Evaluation Brief EB19
Selinda Research Associates, Inc.
December 31, 2008
== DRAFT ==

December 2008 Off-Site Testing
of Wayside Integration Strips

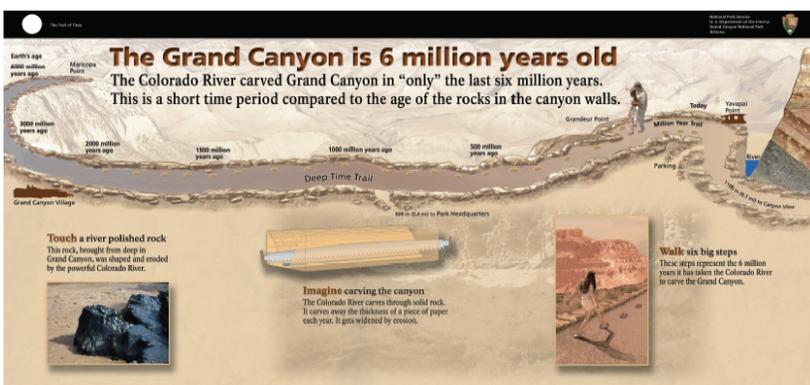
The left side of the WIS in particular was confusing for respondents. Most had difficulty recognizing it as a continuous wrap-around trail. In addition, the 2,000; 3,000; 4,000; Maricopa Point; etc. information tended to be difficult for many respondents.

That's very confusing. It's too much information in too small a space. [Points to left hand side of DDT WIS.]

This is really busy. How do you sort this all out? [Points to left hand side of DDT WIS.]

- Locating themselves along the trail proved challenging for most respondents. Most respondents eventually figured out that they were where the people were standing, but few were able to accurately identify which marker this was. Many respondents suggested that we add a "You are here" bubble.

Does the image of the people on the trail represent where the viewer is (a "you are here" sort of thing)?

- The rock column continued to flummox many respondents. Most either didn't notice it, or if they did notice it, they either had no idea what it was about and spent quite a bit of time puzzling over it, or misinterpreted

If you're trying to get a 3D effect that this is part of the canyon's striations here, or geological record, this looks really out of place. It's really out of place. If you're going to do this [points to the rock column] then why isn't this [points to the canyon walls at the left of the sign] the same way? Because you're looking at the layers right here [points to the canyon walls at the left of the sign]. It's really weird [the rock column]. It's completely out of place.

I thought it was a cliff face.

The other thing that makes it weird, is the scale...If you're saying this [the rock column] represents the geological record, you're looking at the geological record here [the canyon walls at the left of the sign] and you don't see [the layers] there.

The existing "google-earth" depiction was inadequate for most visitors, causing significant amounts of confusion, including the misperception that instead of representing a canyon, the drawing was of hills rising above the trail. The rock column on the right contributed to this confusion as well.

You need to get better art work to create a 3D effect. It's not happening.

Recommendation: Keep the basic idea of a somewhat abstract perspective depiction of a meandering trail laid across the top of the rim, for both the MYT and DTT. Revise the DTT WIS in particular to more effectively communicate a single *Trail of Time* with two components, perhaps by using a perspective drawing similar to what was used in the MYT WIS (without looking the same). De-emphasize (leave off?) the *Early Earth Trail*. Also, on the MYT WIS consider downplaying the huge parking lot and museum off to the left. Be sure to include the Headquarters trail on both the MYT and DTT WISs.

Recommendation: Keep the people on the trail, but add a "You are here" bubble above them. Figure out a better way of labeling the markers so that the year they are standing at is clear.

Recommendation: Keep working. We aren't there yet....One respondent suggested that instead of having a rock column stuck off to the side, the location in the actual canyon walls should be noted instead.

Recommendation: Continue with plans to get a better quality image being careful that this new version clearly communicates that you are standing at the edge of the canyon. Test this next version with visitors at the rim. Consider a view from a higher elevation?
